Re: Florida Power & Light Company  
Proposed Turkey Point Units 6 and 7  
Docket Nos. 52-040 and 52-041  
Response to NRC Request for Additional Information Letter No. 043  
(eRAI 5875) SRP Section - 02.05.03 Surface Faulting

Proposed Turkey Point Units 6 and 7  
Docket Nos. 52-040 and 52-041  
L-2012-018 Page 2

**NRC RAI Letter No. PTN-RAI-LTR-043**

**SRP Section: 02.05.03 – Surface Faulting**

Figure 1. Illustration from USACE lineament study and Barnett (1975) strike-slip fault

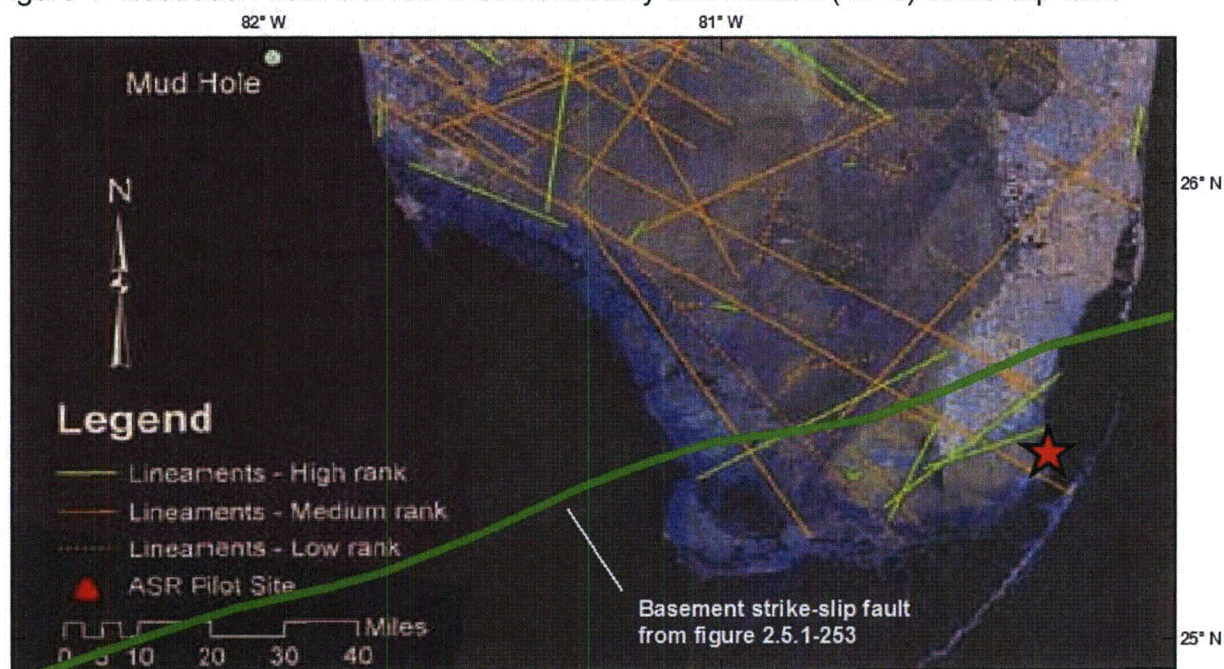
FSAR Section 2.5.3.2, "Geological Evidence, or Absence of Evidence, for Surface Deformation", states that published geologic mapping at a range of scales show no bedrock faults mapped within the site vicinity (References 211, 213, 224, and 226). However, the staff note, that Figure 2.5.1-253 depicts a strike-slip fault within 25 miles of the site; this feature is also shown as a high-rank lineament on Figure 2.5.3-204.

In order for the staff to completely understand the geologic setting of the site and in support of 10 CFR 100.23 please discuss the high-rank lineament shown on Figure 2.5.3-204, and clarify its relationship with the strike-slip fault north of TPNPP shown on Figure 2.5.1-253. Include a discussion regarding how these figures are in agreement with the FSAR Section 2.5.3.2 statement that no faults have been mapped in the site vicinity. Finally, please clarify this apparent disagreement between the text and figures in the appropriate FSAR section(s).

As described in FSAR Subsection 2.5.3.1.2, the USACE mapped a variety of lineaments in southern Florida (FSAR 2.5.3 Reference 232). This study used Landsat imagery at scales between 1:1,000,000 and 1:125,000. The lineaments were not field checked, and the authors indicate that "a considerable number of the mapped lineaments may be dismissed after further investigation" (FSAR 2.5.3 Reference 232, p. 50). The northeast-trending 'high-rank' lineament in question was not identified in previous lineament analyses that included southern Florida (FSAR 2.5.3 Reference 232). The lack of supporting corroborating analyses on the existence of the lineament, the coarse nature of the lineament identification study dictated by the small scales at which the lineament analysis was conducted, and the lack of field evidence all provide poor evidence for the existence and geometry of the high-rank lineament.

As described in FSAR Subsection 2.5.1.1.1.13.2.1, the postulated basement faults shown on Figure 2.5.1-253 are drawn to accommodate potential misfits in plate tectonic reconstruction models or differences in lithology from widely separated boreholes, and thus, little evidence directly indicates actual displacement has occurred on these postulated structures. There is no clear relationship between the postulated buried strike-slip basement fault depicted in Figure 2.5.1-253 and the high-rank lineament on Figure 2.5.3-204. As shown in Figure 1, the two features are both northeast-striking, but have different geometries, extents, and locations. No geologic evidence of faulting is reported to support a tectonic origin for the lineaments identified in the study, and no evidence was provided to relate the postulated basement faults at depth to any lineament at the surface (FSAR 2.5.3 Reference 232). The original study did not interpret a geomorphic expression for any of the postulated basement faults depicted in Figure 2.5.1-253 (FSAR 2.5.1 Reference 458).

FPL interprets the similarity in general location (southern Florida) and strike (northeast) to be coincidental.

There is no evidence for faulting along any of the lineaments within the site vicinity in FSAR Figure 2.5.3-204, therefore, this feature does not conflict with any statement made in the FSAR. The FSAR will be revised, however, to reflect the existence of a postulated buried basement fault shown in Figure 2.5.1-253 within the site vicinity.

Figure 1. Map of McGregor Isles area

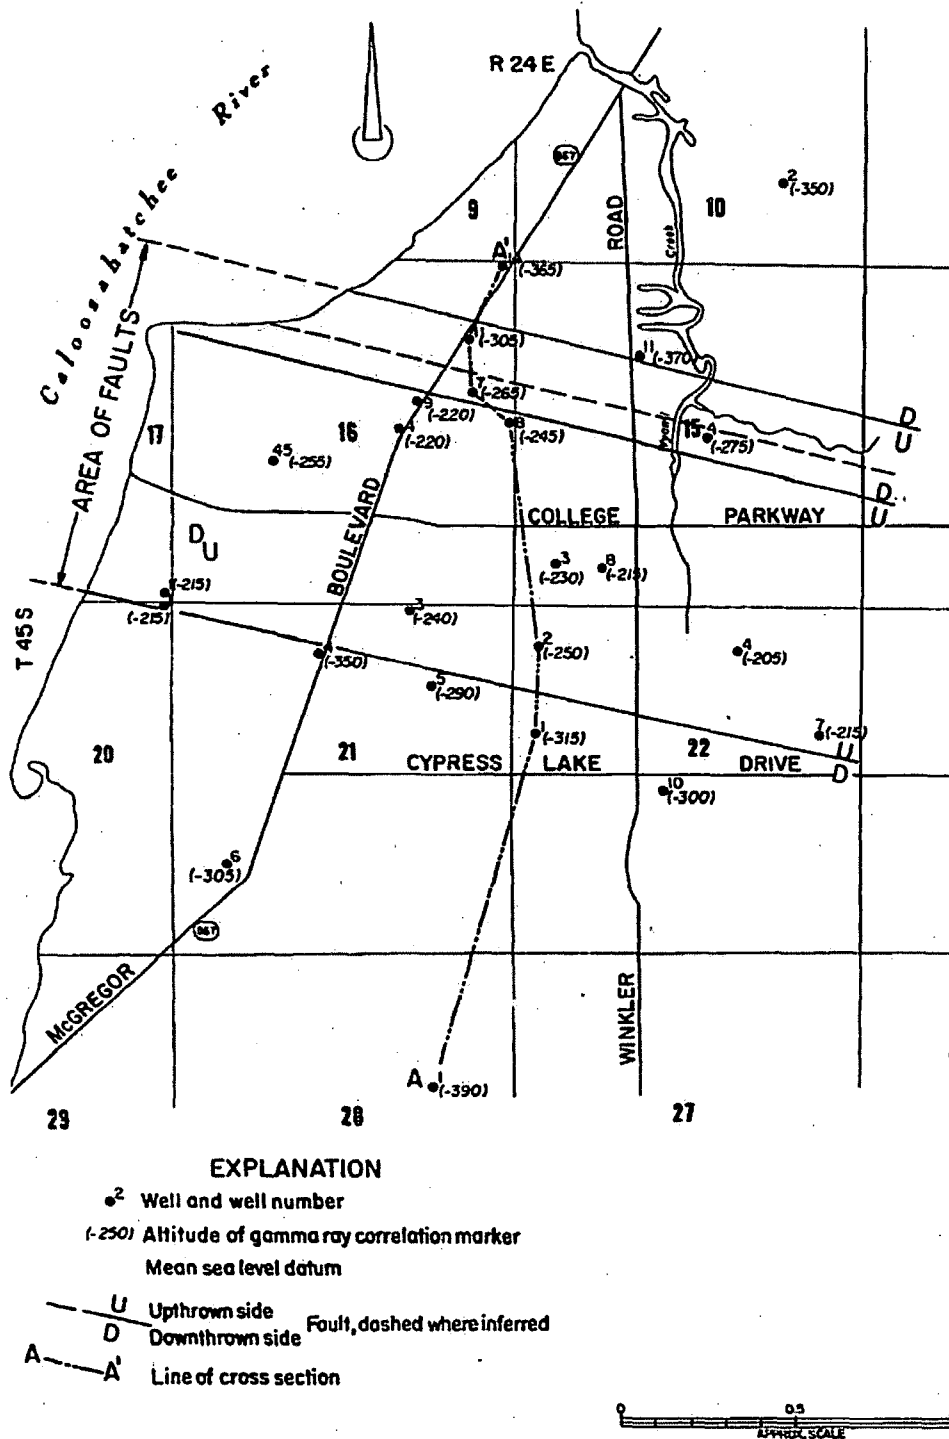
In order for the staff to understand evidence for or against tectonic deformation in Florida Platform specific geology and in support of 10 CFR 100.23, please clarify the apparent inconsistent conclusions that Sproul et al (Reference 230) drew regarding these possible faults. Describe the geomorphic features that Sproul et al referred to and provide more details of your field reconnaissance examination of this area completed for this application.

Sproul et al. suggest that the 'configuration of the Caloosahatchee River shoreline in the vicinity of the northeast corner of section 17 (in Figure 1), and the alignment of a tributary to Whisky Creek near the center of section 15 are suggestive of fault controlled features

(p. 12 of FSAR 2.5.3 Reference 230) (Figure 1). However, the shoreline throughout the northwest corner of section 16, and the southwest corner of section 17 does not indicate an alignment with the faults (Figure 1) and the orientation of the main creek drainage in section 15 is at high angles to the trace of the mapped faults, with no apparent offset or deflection along the proposed structures (Figure 1).
